UNITED STATES ENVIRONMENTAL PROTECTION AGENCY  
WASHINGTON, D.C. 20460

March 28, 2003

## COMMENTS ON THE DECEMBER 2002 RH PROPOSAL

## Waste Characterization Program Implementation Plan (PIP)

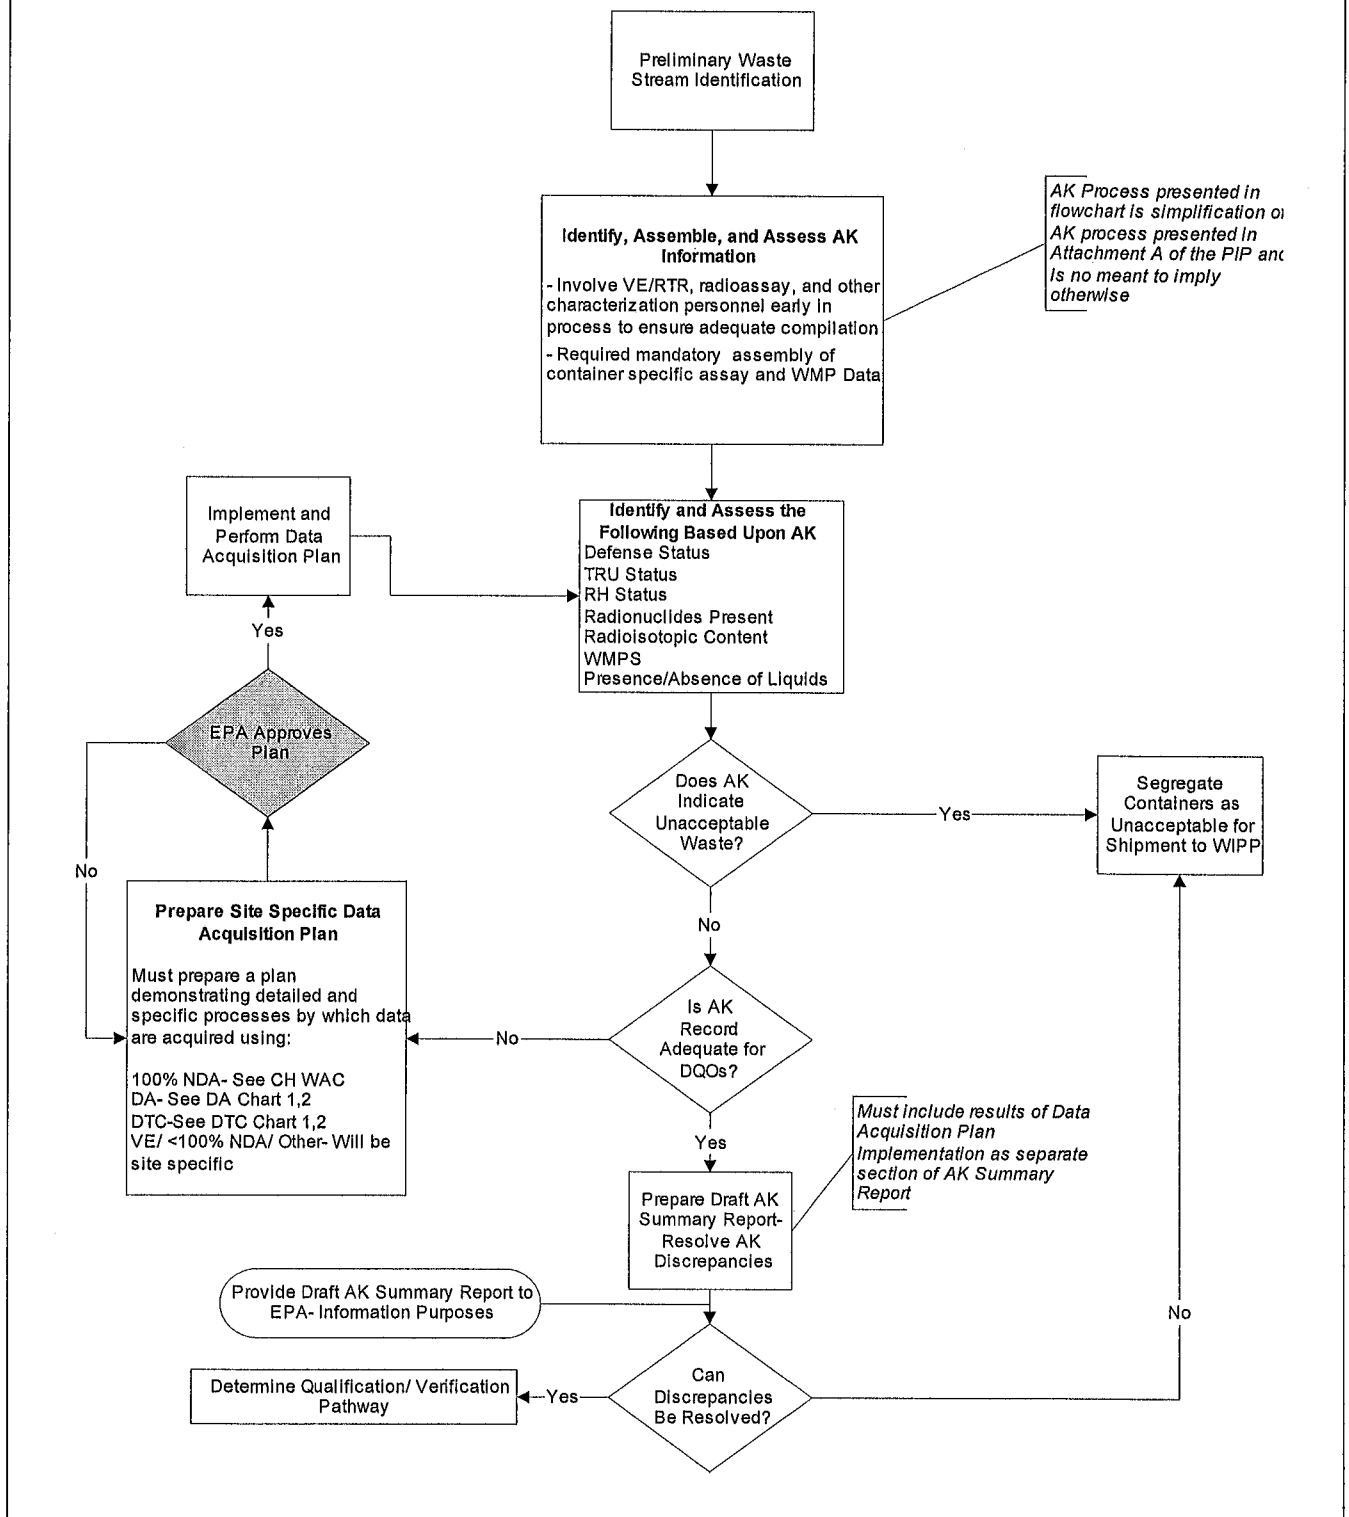
**AC-20. Revision 7, Page 10.** The two dose rate measurements described as “12 and 6 o’clock” are made at 180 degrees and not 90 degrees as stated in the second bullet on page 10.

## Site Specific RH Waste Characterization Process Flow Diagram Guidance (For Information Only)

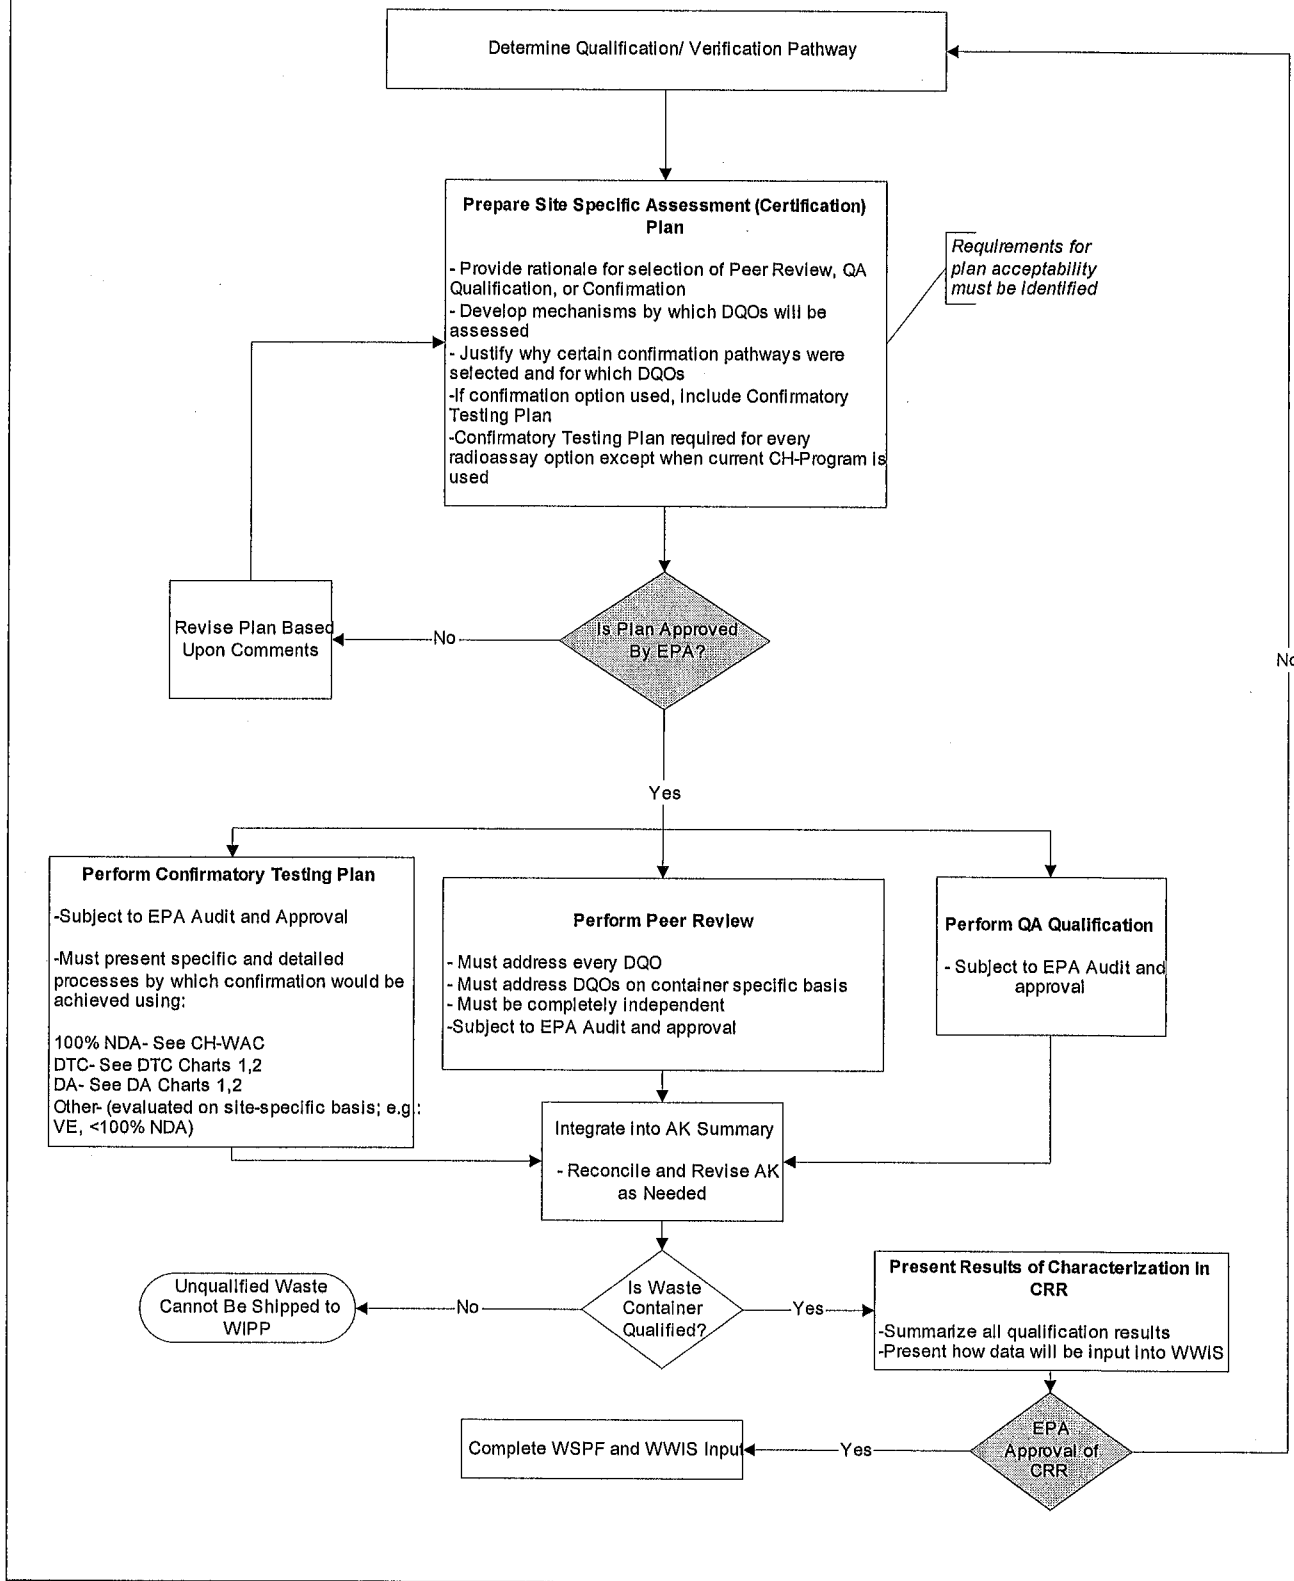
**PIP-5. Section 2.3, RH TRU Waste Characterization Process, page 11.** (*EPA Site Specific RH Waste Characterization Process Flow Diagram*). The characterization process described in this section should be clarified, as the information is confusingly presented. DOE states:

*(EPA Site Specific RH Waste Characterization Process Flow Diagram, Identify, Assemble and Assess AK Information)* As presented in comments on Attachment A, the AK record must contain container-specific information, if available, on waste material parameters. Also, waste material parameter descriptions must explicitly be included in the AK record for each waste stream. This is required because the WWIS will include simplifications that do not reflect the actual waste content, and this information is required to ensure that the wastes are appropriately grouped and waste stream identification is adequate. In addition, revisions to the visual examination procedure (Section 4.4.1) to require more detailed information beyond the percent fill for DTC should be mandated; that is, visual examination could be used on a waste-specific basis to obtain matrix information necessary to perform DTC characterization, and the procedure must be flexible enough to allow this type of characterization if necessary.

**PIP-19. Section 4.1.2 Acceptable Knowledge, pages 27 and 28.** (*EPA Site-Specific RH Waste Characterization Process Flow Diagram*) The PIP does not clearly state that the first step to the characterization process is to assemble AK information. As written, the assembly of AK information can be construed as arbitrary, and this contradicts statements made elsewhere in the RH Proposal. The AK description must include not only the Summary Category Group, but the specific waste material parameters within waste streams. The AK Summary Report documentation need not be exhaustive, but as the DOE expects more reliance on the AK for RH waste characterization, the AK record must be auditable and sufficiently robust to justify all designations and to allow EPA inspectors to completely understand statements and assignments within the AK Summary. Also, with respect to radiological information, the amount and quality of these data must be clearly presented. In addition, because the RH program relies on AK so heavily (more so than the CH program), the RH program must specifically require that site assemble and assess all container-specific data pertaining to both radionuclides and waste material parameters. This information should be assembled on spreadsheets or similar presentation formats, and should be evaluated and assessed in the AK Summary. Also, radioassay personnel should be involved in the AK data assembly and evaluation process to ensure appropriate data evaluation—for example, information concerning solid waste heterogeneity and other aspects important to supporting destructive assay must be recorded. All supporting spreadsheets and copies of container-specific AK data should be in the AK record, or adequately referenced so that during the EPA inspections, inspectors can readily obtain and examine the information. Inclusion of this information is necessary, because it will be an important element of our review when assessing whether the appropriate decisions were made with regard to pursuing confirmation or peer review, or perhaps identifying data gaps in the AK

## DTC Chart 1

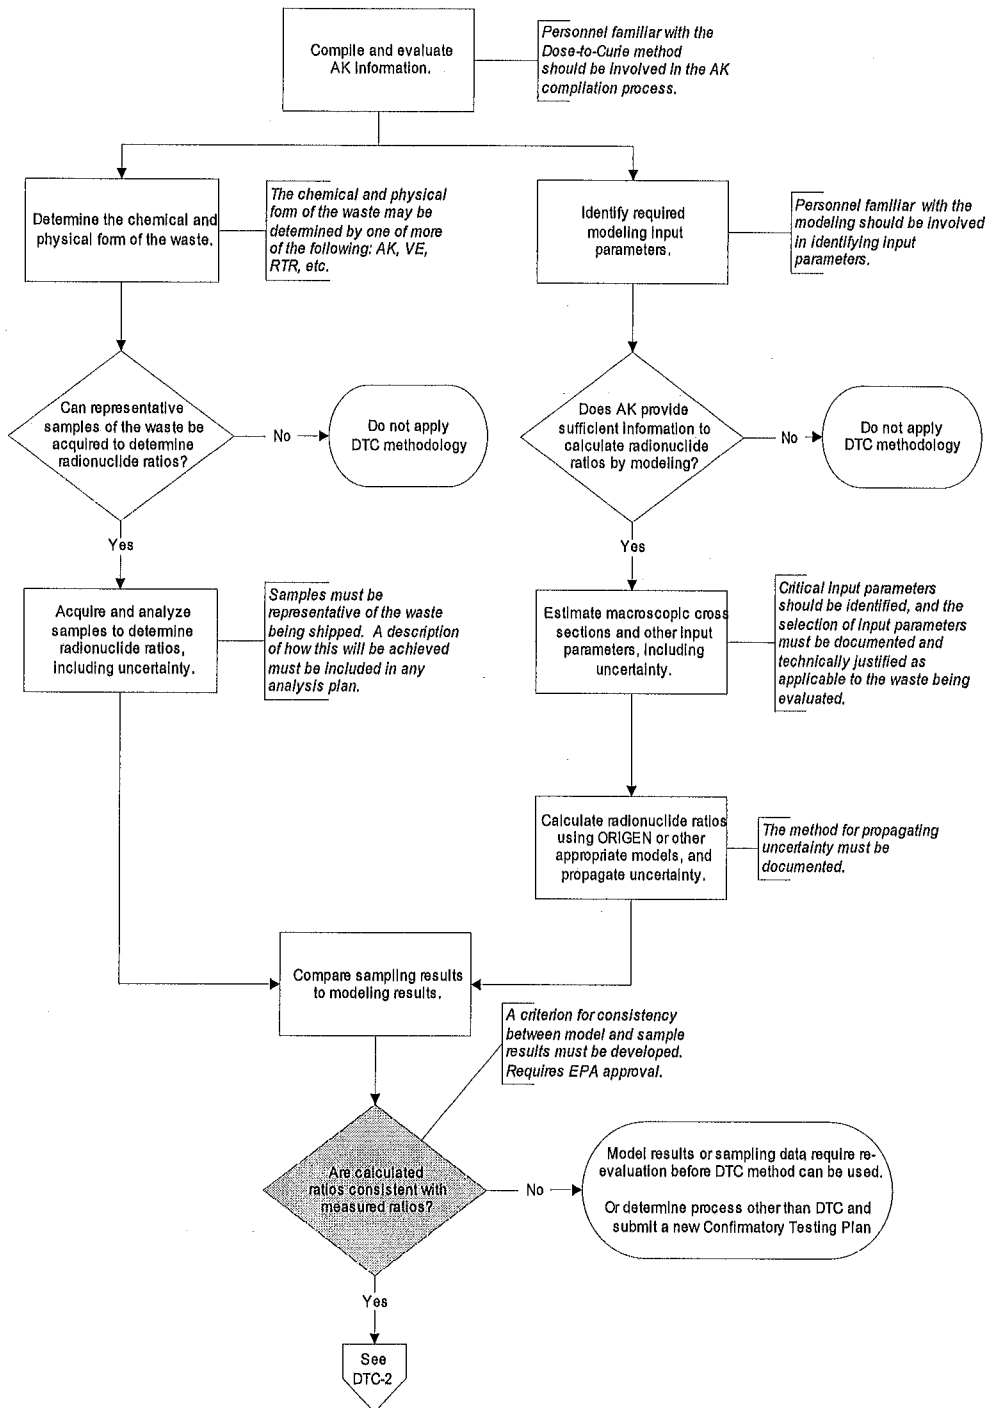
Requirements of DTC Confirmation Plan should included but not be limited to:

- Identify DTC Options and criteria for selecting each of these options.
- Define types of waste that are eligible for DTC confirmatory assessment (physical and chemical limitations)

- Define Data Quality Objectives (DQOs) for activities related to the DTC method, including sampling, modeling, and dose rate measurements
- Establish radionuclide ratios for each of the ten (10) WIPP-tracked radionuclides:  $^{90}\text{Sr}$ ,  $^{137}\text{Cs}$ ,  $^{233}\text{U}$ ,  $^{234}\text{U}$ ,  $^{238}\text{U}$ ,  $^{238}\text{Pu}$ ,  $^{239}\text{Pu}$ ,  $^{240}\text{Pu}$ ,  $^{242}\text{Pu}$ , and  $^{241}\text{Am}$ .

## DA Chart 1

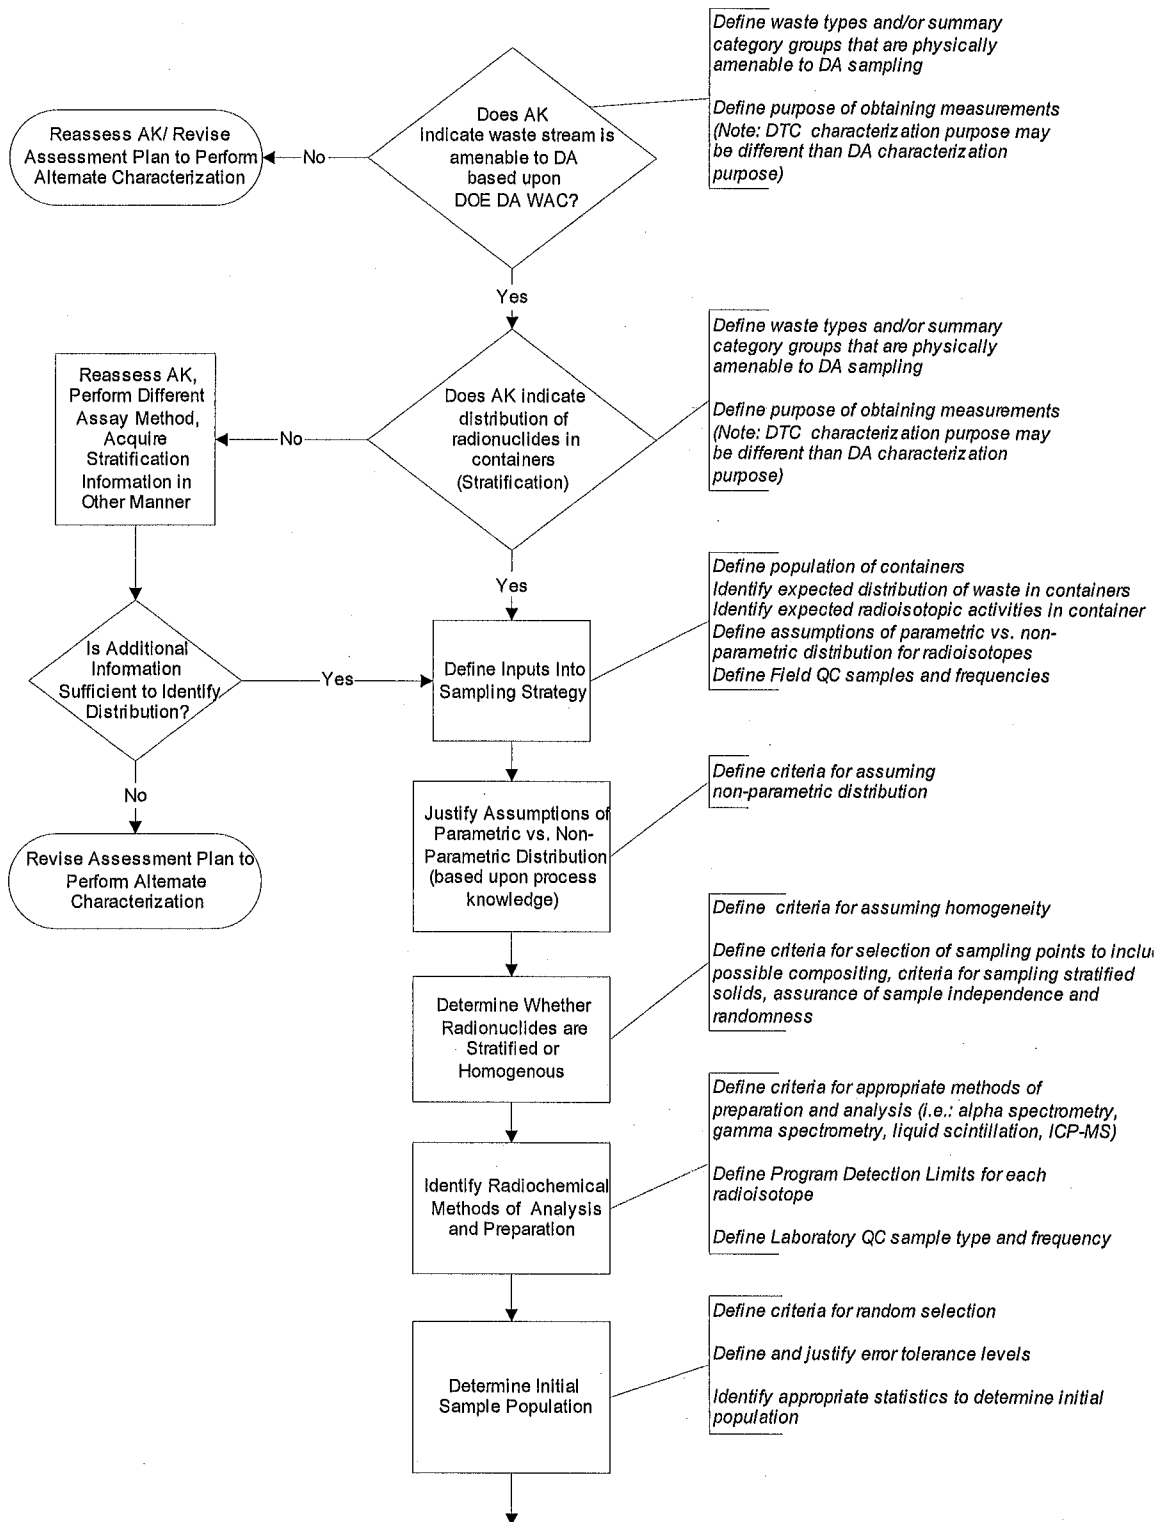
**PIP-14. Section 3.5, Data Management** *(See EPA DA Chart 1, Bullets 5-17 regarding management of data; DA Chart (continued) All Decision Boxes and all but the first two Process Boxes (sample collection and analysis)* The current version of the Data Management section does not detail how validation/verification activities and reconciliation activities will be performed and does not indicate how DOE intends to resolve nonconforming data. DOE should define data management criteria that allow the sites to ensure the quality of characterization data and to ensure that characterization data is appropriately used in making characterization decisions. DOE should provide further definition and/or clarification for the elements of Data Management to include but not intended to be limited to:

Requirements of DA Confirmation Plan should included but not be limited to:

- Specify DA specific DQOs (i.e.):
  - Define tolerable limits of error
  - Define minimum levels of detection
- Define types of waste that are eligible for DA confirmatory testing (physical and chemical limitations)
